FACTORY SERVICE BULLETINS

ESP Ground Connection

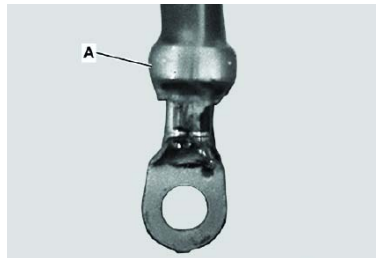
The ESP ground connection, located just ahead of the left shock tower, may not be properly installed. The ESP control module harness plug should also be checked for moisture intrusion.

1. Loosen ground nut at W16/3 (Figure 1) and remove ESP Control Module ground wire (thick wire), as well as all other wires.
2. Remove heat shrink from cable lug completely, being careful not to damage the wire insulation.
3. After the heat shrink is removed from the cable lug, remove the heat shrink from the ground wire itself.
4. Unplug the ESP harness plug from the ESP Control Module.
5. Carefully tap the unplugged harness plug against your hand to remove any moisture and blow out the ESP harness plug with dry compressed air while elevated above the ground cable, for at least three minutes, at the ground pins to completely remove any moisture.
6. Blow out the multi-pin connector directly at the ESP Control Module, then

7. Install new heat shrink tubing onto ESP Control Module ground wire (thick wire), ensure that the heat shrink tubing stops where removed (A in illustration) and does not cover crimped end.

8. Place the 6 x 1.2 mm washer onto the ground stud at W16/3. Install thin ground wires first, then reinstall the ESP ground wire (thick wire) and secure with the previously removed ground nut, tightening the nut to 10Nm.
